# Access Compliance Report

## Public Rights-of-Way

Intersection ID: 3027	Main Street: BROWNE_RD	Cross Street: AMBER_GLEN_DR	Location: W
ADA ID: 77FB14445CDD	Ramp Type: BlendTrans2	Initial Pass/Fail: Fail	Overall Compliance: No
		Severity Score: 25

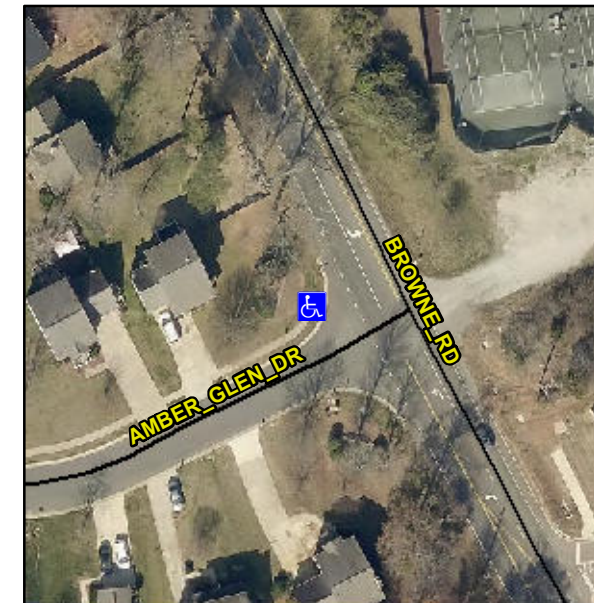
**Not Found, R304.5.3**

Compliance	Description	Data	Compliance	Description	Data
N/A	Ramp Length (in)	96.0	Yes	BlendTrans Slope (%)	2.2
Yes	Ramp Width (in)	95.0	No	BlendTrans XSlope (%)	7.3
N/A	Flare Type LT	N/A	N/A	Flare Type RT	N/A
N/A	Flare Slope LT (%)	N/A	N/A	Flare Slope RT (%)	N/A
N/A	Flare Traversable LT?	N/A	N/A	Flare Traversable RT?	N/A
N/A	Landing Length (in)	N/A	N/A	DWS Provided?	N/A
N/A	Landing Width (in)	N/A	N/A	DWS Contrast?	N/A
N/A	Landing Slope (%)	N/A	N/A	DWS Length (in)	N/A
N/A	Landing X Slope (%)	N/A	N/A	DWS Full Width?	N/A
N/A	Landing Curb? (Y/N)	N/A	N/A	DWS Offset (in)	N/A
N/A	Shared Landing?	N/A			
N/A	Gutter Ponding?	N/A	N/A	Gutter Slope (%)	N/A
N/A	Gutter Lip Ht (in)	N/A	N/A	Gutter X Slope (%)	N/A
N/A	Painted X Walk1?	No	N/A	Painted X Walk2?	No
	X Walk 1 Direction	To S		X Walk 2 Direction	To E
	X Walk 1 Width (in)	N/A		X Walk 2 Width (in)	N/A
	X Walk 1 Slope (%)	N/A		X Walk 2 Slope (%)	N/A
	X Walk 1 X Slope (%)	N/A		X Walk 2 X Slope (%)	N/A

N/A	Ramp inside XWalk1?	N/A	N/A	Ramp inside XWalk2?	N/A
	Road Slope (%)	3.1		Clear Space?	N/A
	Road X Slope (%)	3.6	N/A	Clear Space to XWalk (in)	N/A
N/A	Any Obstructions?	N/A	N/A	Storm Grate/Utility Hazard?	N/A
	Obstruction Type			Storm Grate/Utility Type	
		N/A			N/A
			Yes	Surface Condition? (G/P)	Good
			No	Curb Slope (%)	14.2

**Remove & Replace Curb Ramp With Two New Directional Ramps or Equivalent.**
